MARQUETTE CITY PLANNING COMMISSION
Tuesday, June 03, 2025, at 6:00 p.m.
Commission Chambers at City Hall – 300 W. Baraga Ave.

TO: Planning Commission
FROM: Andrea Landers, Zoning Official
DATE: May 28, 2025
SUBJECT: 01-PUD-03-25 (05-SPR-06-25) – Preliminary PUD plan review for W. Magnetic St (Portion of PIN: 0410681))

Project/Application: Preliminary PUD Approval and Site Plan Review for a proposed Planned Unit Development (PUD) for a mixture of Townhome types (one-unit, duplex, triplex, and six-unit) for a total of 36 units to be located at the three existing parking lots on the south side of W. Magnetic Street between Lee Street and Fourth Street.

TO: Andrea Landers
FROM: Jeff Fossitt
DATE: 04-28-25
SUBJECT: 05-SPR-06-25 and 01-PUD-03-25
Parcel Numbers: 0410681
Magnetic Street

ISSUE DATE	FOR	Designed By:
4/22/25	REVIEW	LBS
5/5/25	REVIEW	Checked By: BMS
		Drawn By: LBS
		Approved By: BMS
		PROJECT # 24042
		SHEET NO. 13
		DWG. NO. C-04.2

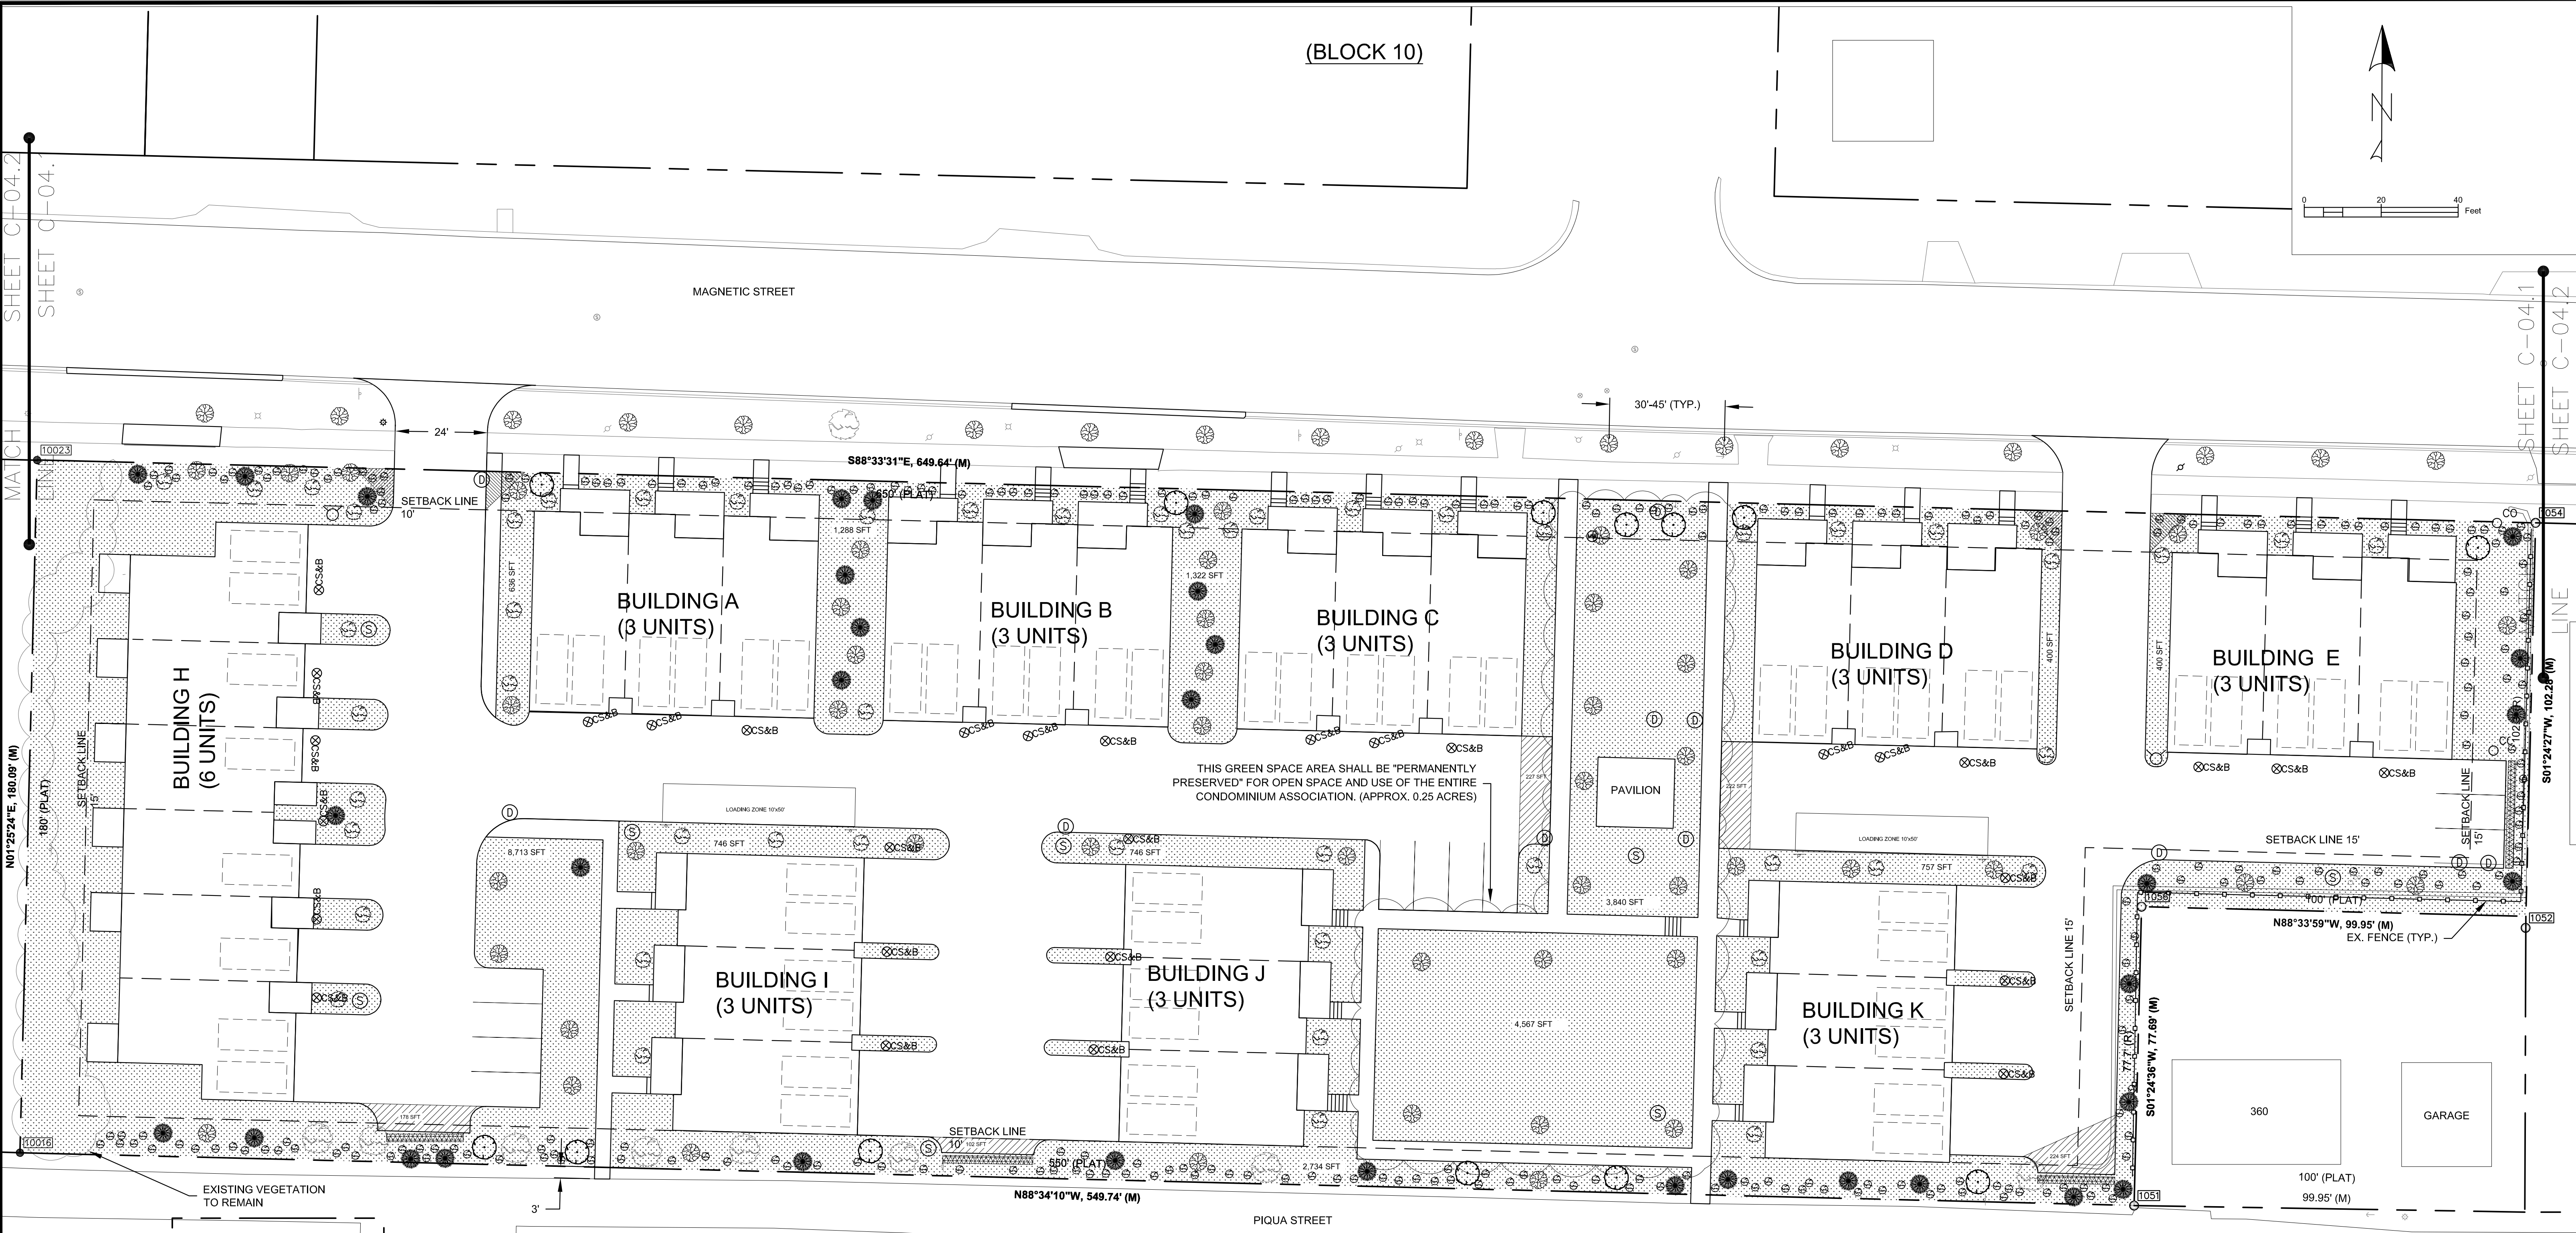
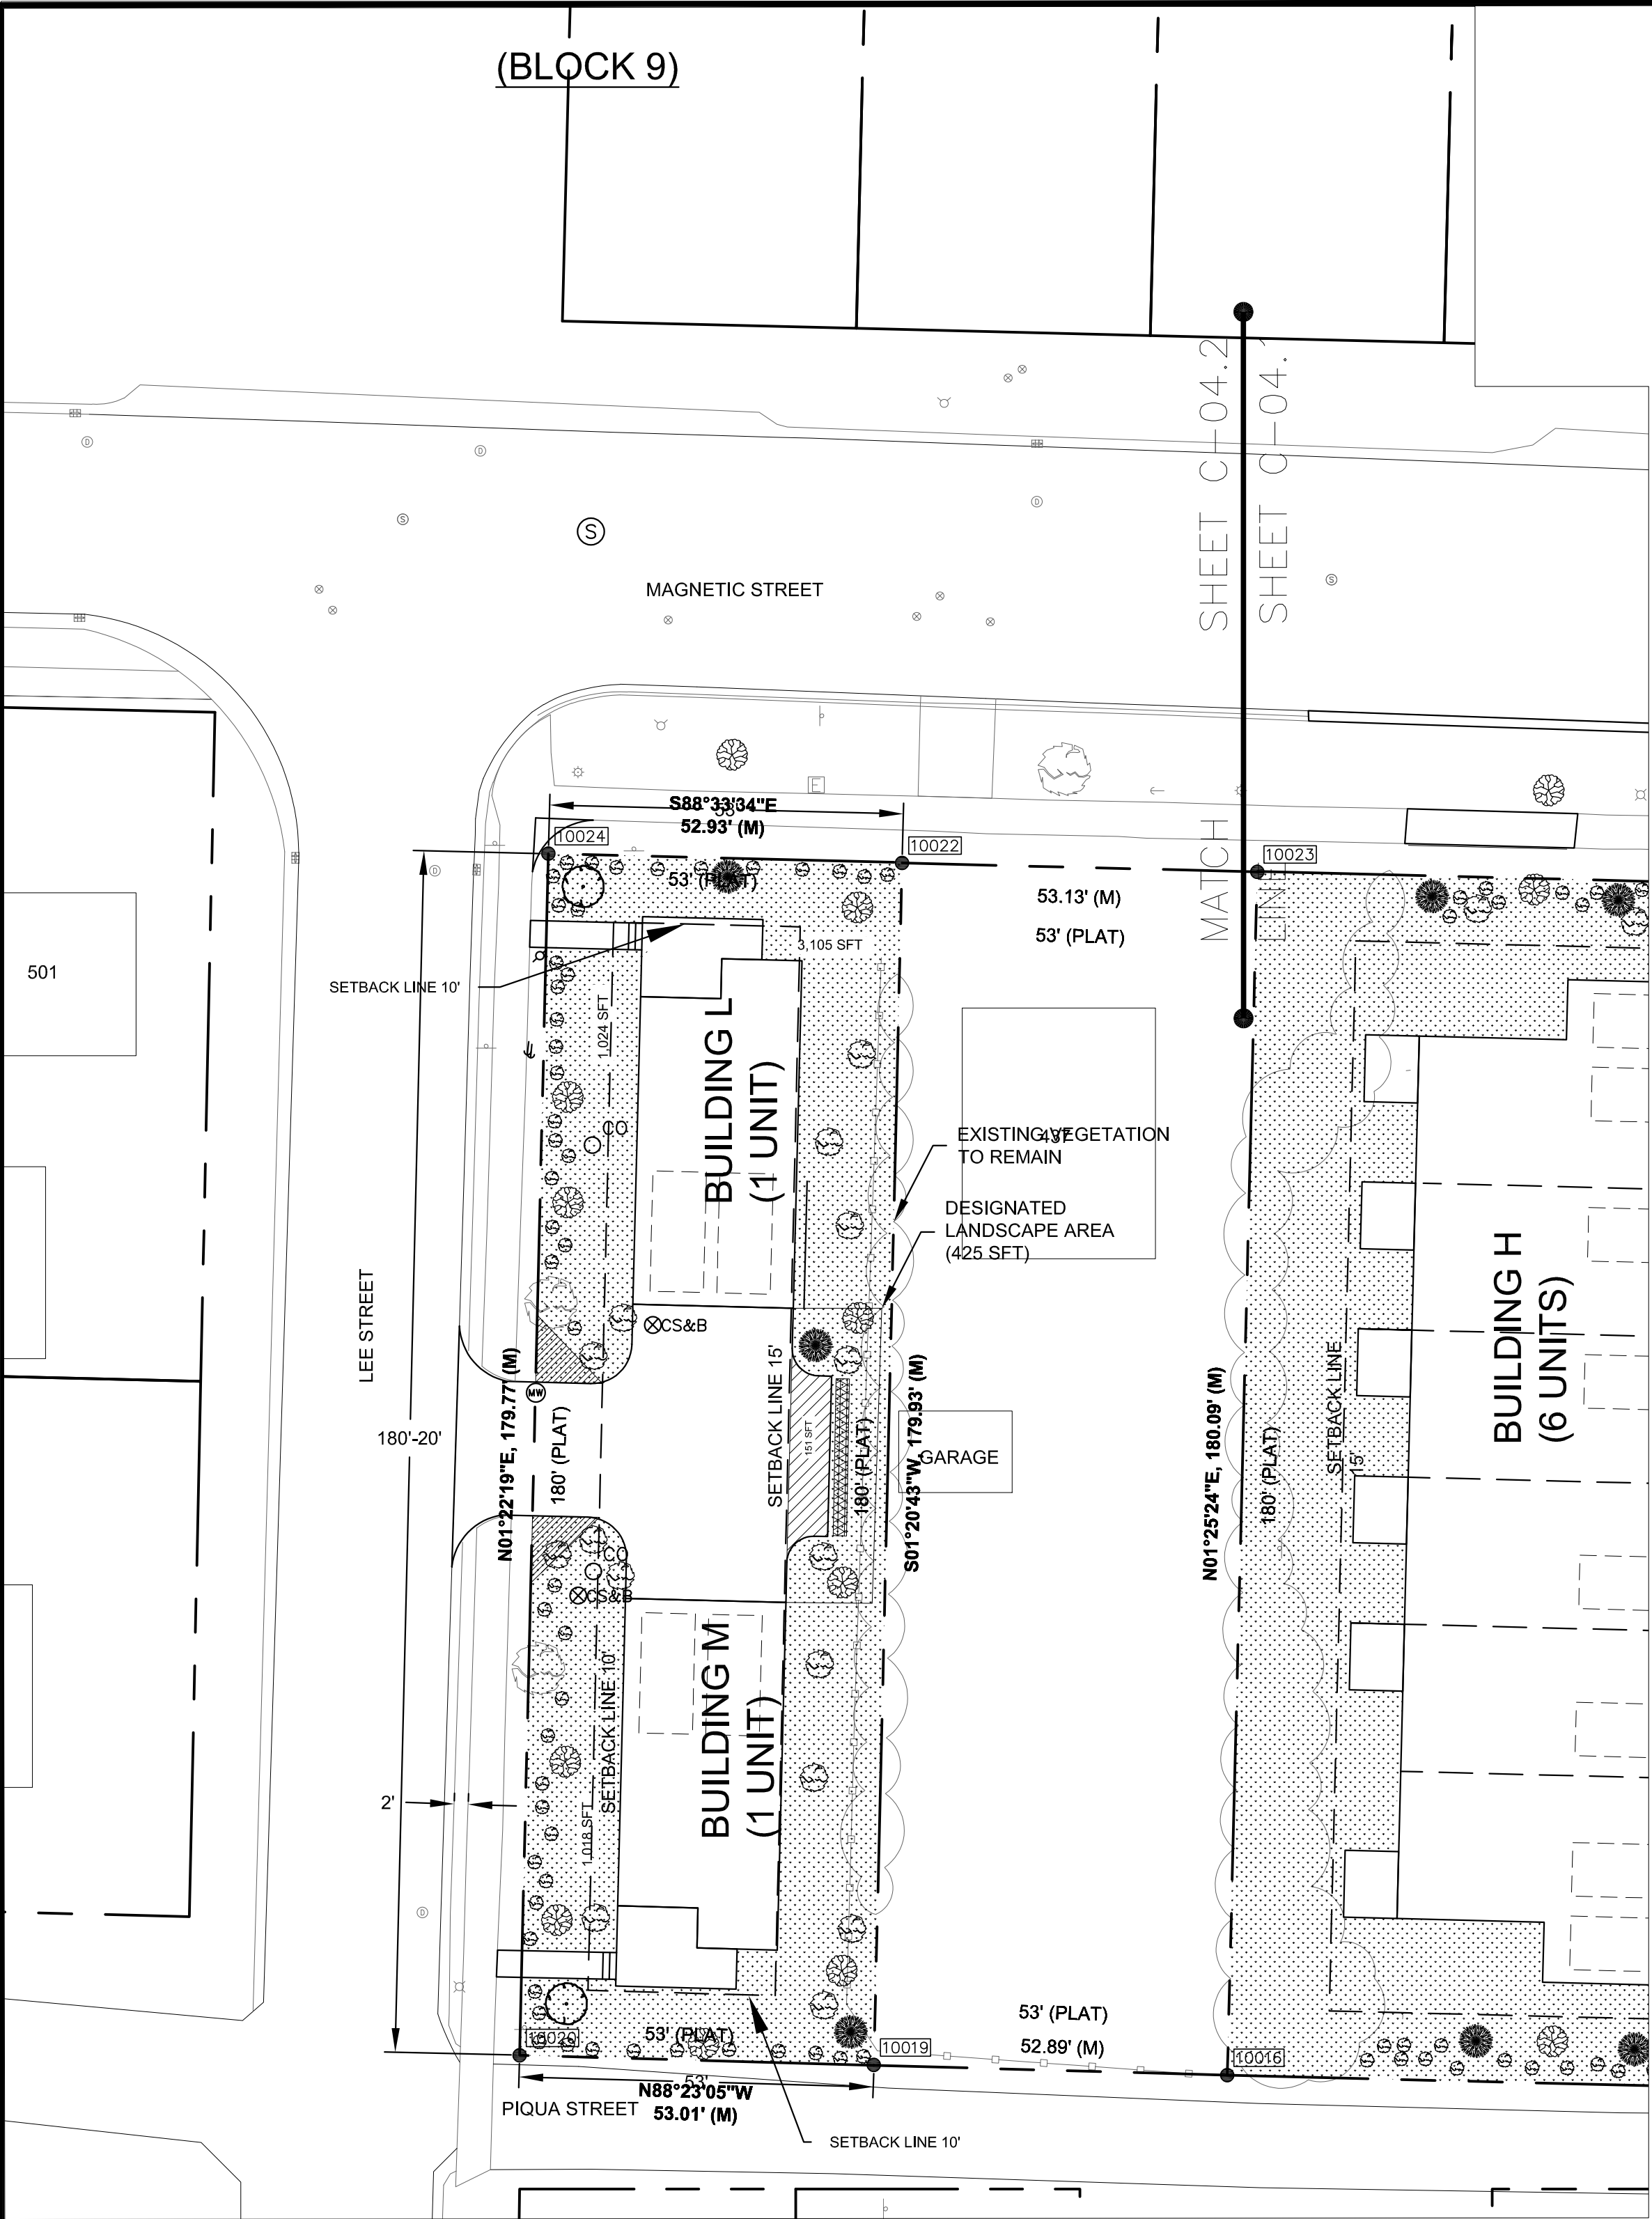
See Sheets C-04.1 and C-04.2 for the landscaping plan. Please see Zoning comments and applicant's responses regarding the proposed landscaping for the site.

- **Section PUD (H)(1)(K) – We have Added Notation to the Landscape Plan sheets C-04.1 and C-04.2 indicating that all of the Green Area and Buffer Yard Landscape areas will be permanently preserved, and the Condominium Association will be responsible to provide annual maintenance of these areas and provide re-planting as necessary.**

- **On Sheet C-04.1 we have also added notation that the large green space including the proposed Pavilion will be permanently preserved area for the entire Condominium Association.**
